CONSTRUCTION DOCUMENTS REVIEW

2-04-05

RE: QUIZNOS SUB
#8336 Plaza 190 S/C
188 Gaube Blvd. West
Slidell, LA 70458

REVISED
EQUIPMENT
PLAN

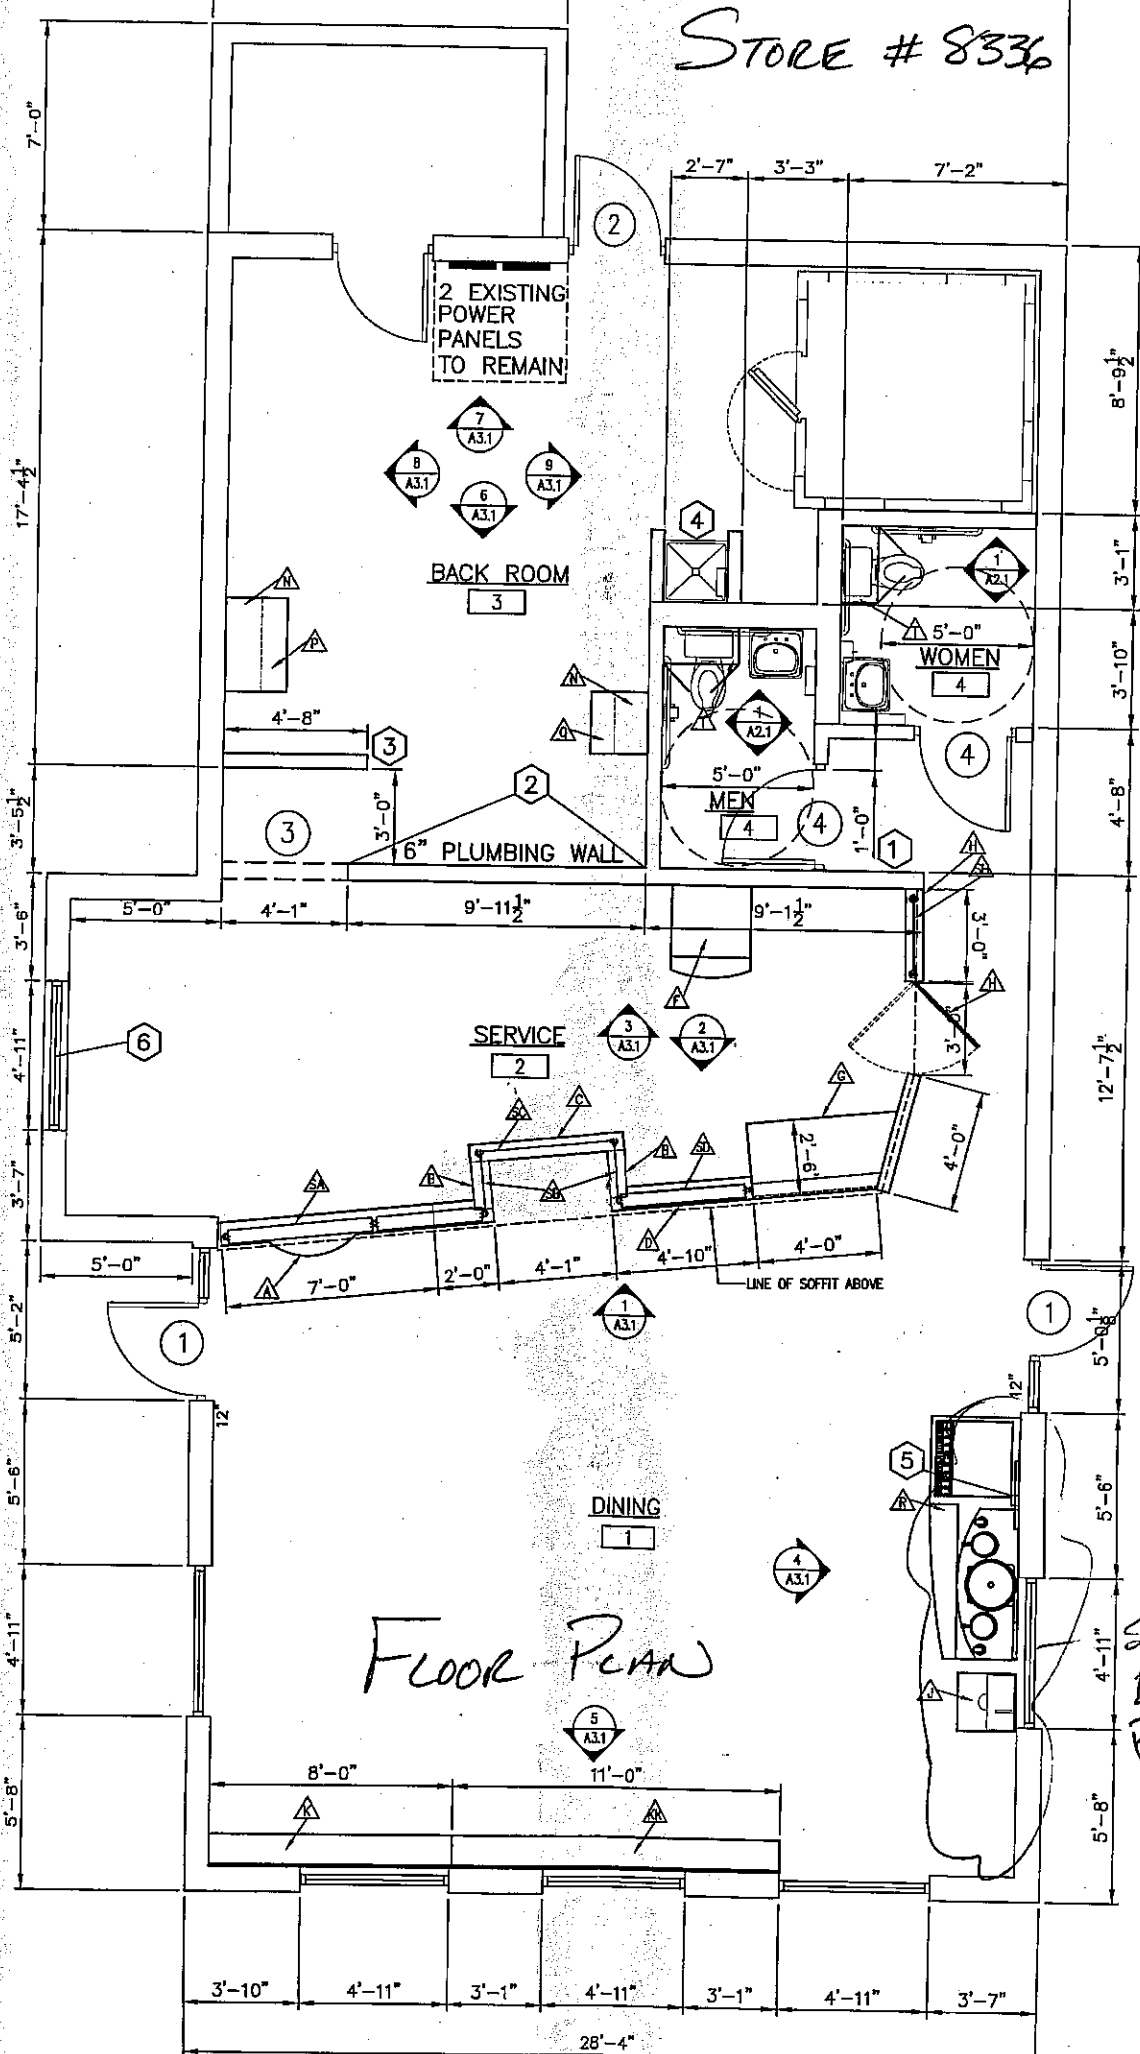
- d. A **NONSTANDARD** QVent will be ordered per the QVent worksheet.
 - e. **An 8' X 8' X 8'6" freezer, REMOTE compressor, will be ordered per the Kolpak worksheet. Verify.**

- h. **Verify clearance of service line due to toaster moving.**
- i. All millwork will be ordered as standard prototype sizes.
- j. Note: all sneeze guard glass must be angled 15 degrees, VERIFY.

(KOLPAK WORKSHEET). TOP MOUNT IS THE STANDARD AND WILL BE OR (VIA KOLPAK WORKSHEET). THE STANDARD FREEZER HEIGHT IS 9'-6" & SPECIFIED (VIA KOLPAK WORKSHEET). A CEILING HEIGHT OF 13'-0" MIN FOR TOP MOUNT COMPRESSORS. A CEILING HEIGHT OF 10'-0" MIN. CL FOR REMOTE COMPRESSORS.

*block-off
cannot
use.*

*62
ARTWORK
HERE*

(FINISH FLOOR PLAN)
SCALE: 1/4" = 1'-0"

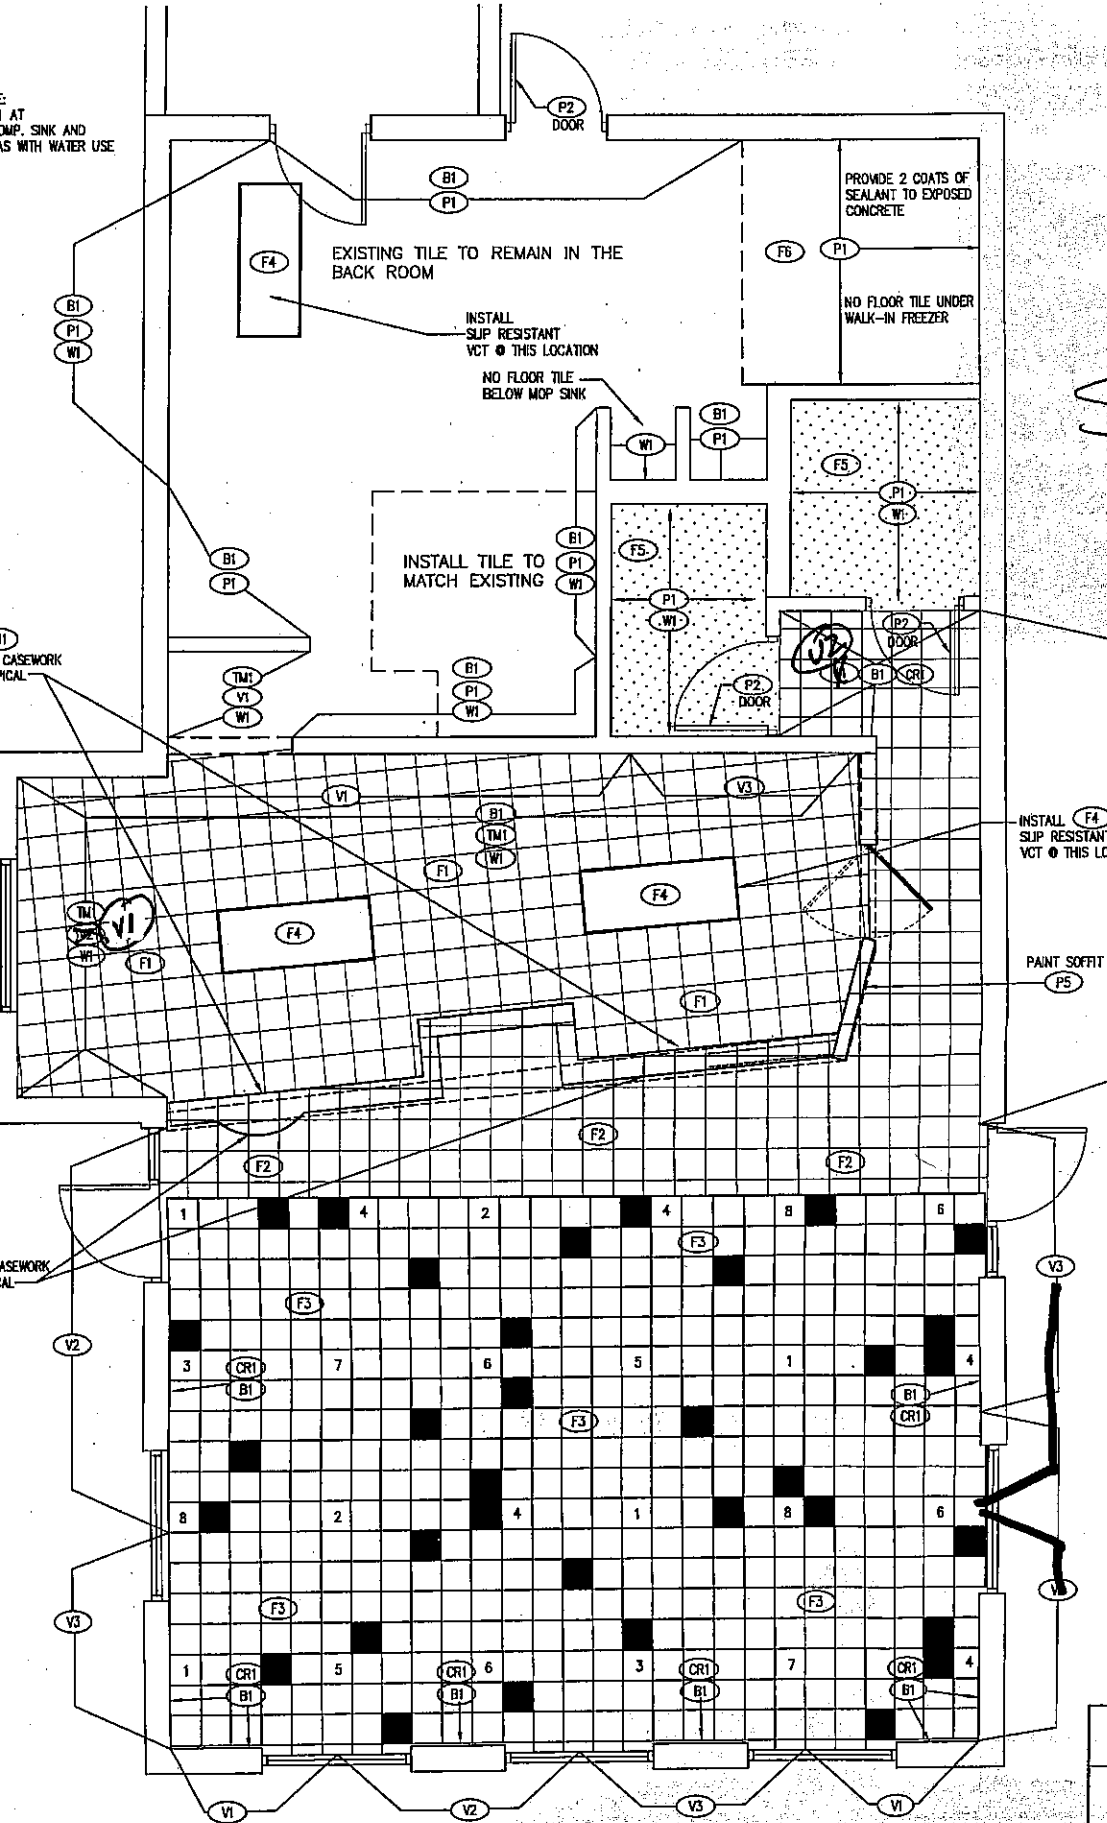
- m. Add artwork G2 to indicated area. (See attached).
- n. The "D", lights are located incorrectly. Refer to addendum #4 for correct placement and correct fixtures (see attached).

- o. Verify the 'D' lights are mounted along the centerline of the soffit.
- p. The Track lights are located incorrectly. Refer to addendum #4 for correct placement and correct fixtures (see attached).

- q. The "B" lights are located incorrectly. Refer to addendum #4 for correct placement and correct fixtures (see attached).
- r. Move the "F" lights as shown. (See attached).

- s. Emergency lights are required at each entrance/exit. They will be ordered. (See attached).
- t. Verify that shelving either needs to be ordered for the cooler or not.
